REFERENCE:	Nova Bus Manuals
SECTION:	12: Interior Furnishing
RS N°:	MQR 7621-1007
EFFECTIVE IN PROD.:	N/A

SUBJECT:	Articulation stanchion
JUSTIFICATION:	A new stanchion was designed to cope with conditions where vehicles are exposed to extreme road vibrations. The original stanchion supplied with vehicles listed below is now discontinued and replaced with this new design. This document outlines the Installation instructions needed if a stanchion needs replacement.

Figure 3 - Removal of Stanchion

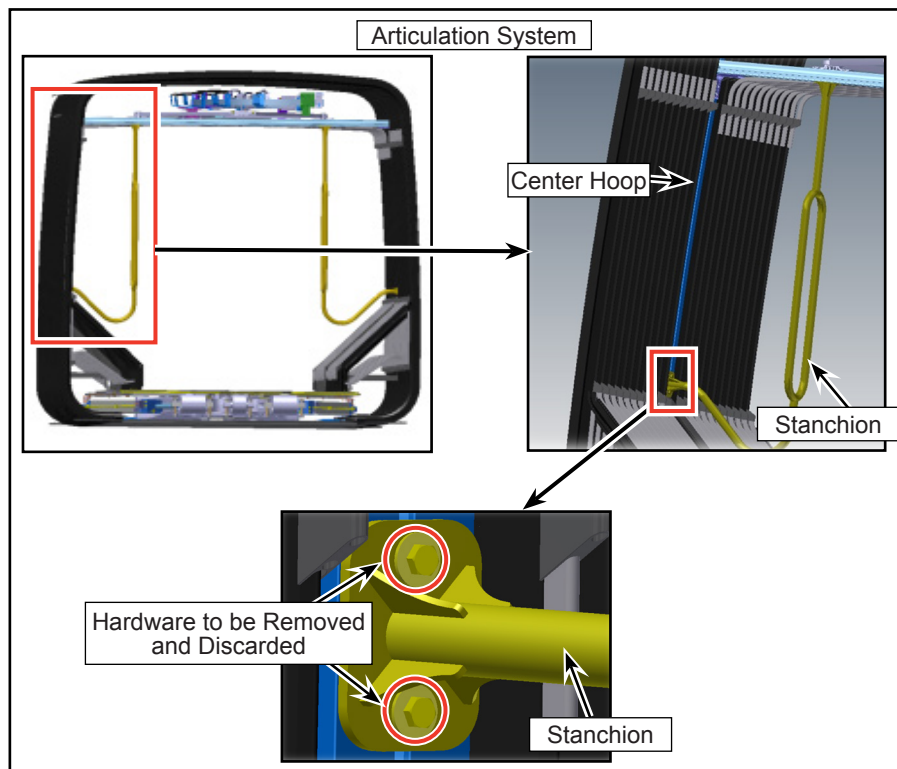
- 1.4. Remove the existing stanchion on both sides fixed to the center hoop of the articulation. Discard the stanchion, bolts and washers (see Figure 3).

Figure 4 - Typical View of Tenon Block

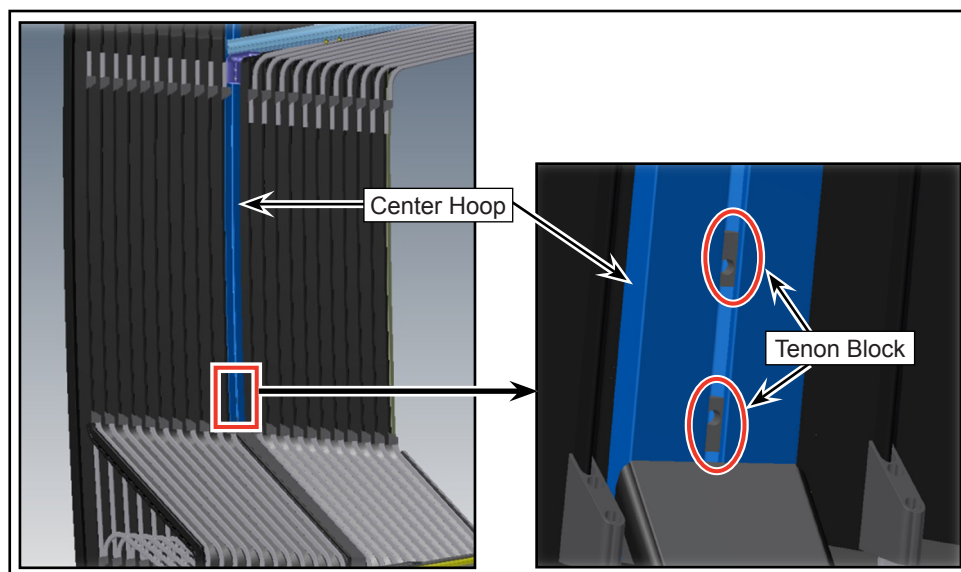
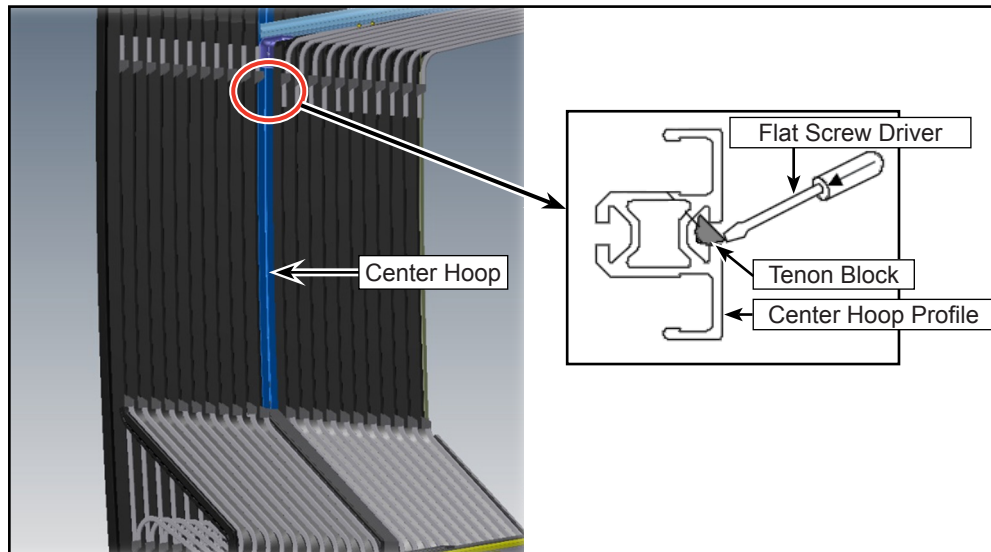
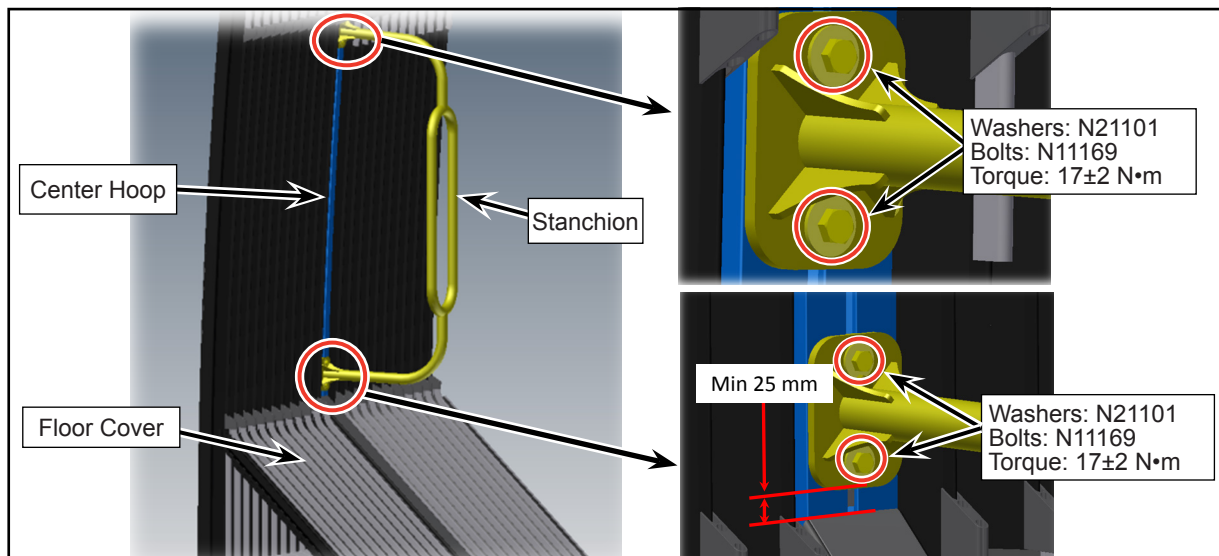
- 1.5. Retain the tenon blocks at the same location (inside the center hoop aluminium profile) as shown (see Figure 4).

- 1.6. Install the new tenon block into the center hoop profile (right below the horizontal guiding profile) on both sides with a flat screw driver as shown (see Figure 5).

- 1.7. Install the new stanchions on to the tenon block present inside the center hoop profile with the hardware provided (see Figure 6).
- 1.8. Ensure that enough gap (Min. 25 mm) is left between the lower edge of the stanchion and the floor cover profile as shown (see Figure 6).
- 1.9. Apply blue thread locker and torque the bolts as specified (see Figure 6).

Figure 7 - Typical View of Stanchion Orientation

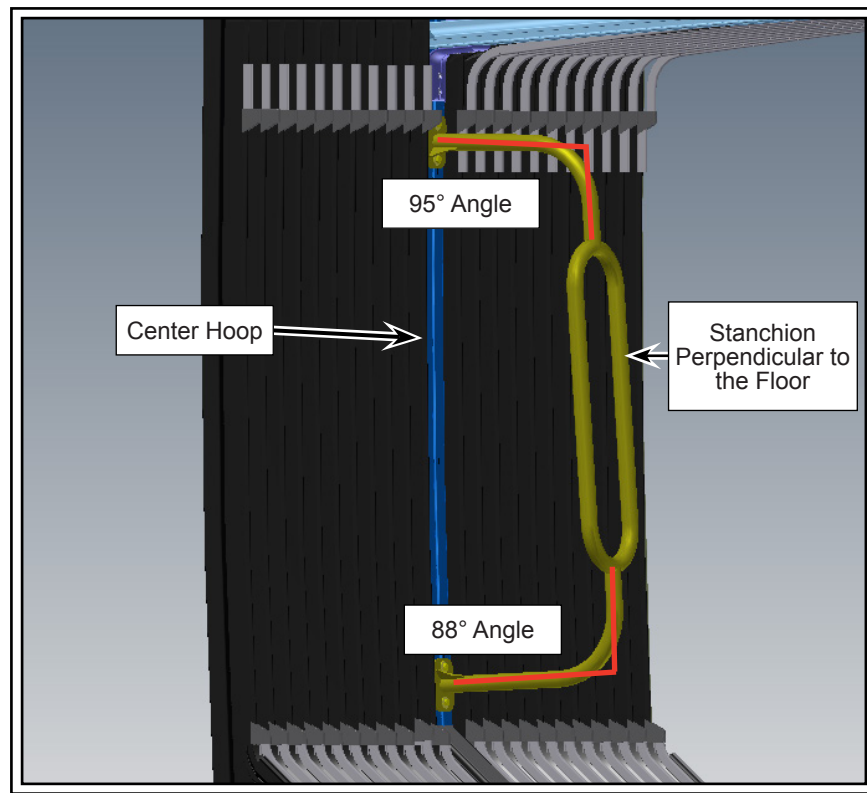
- 1.10. Ensure that the stanchion on both sides are vertical (perpendicular to the floor) (see Figure 7).
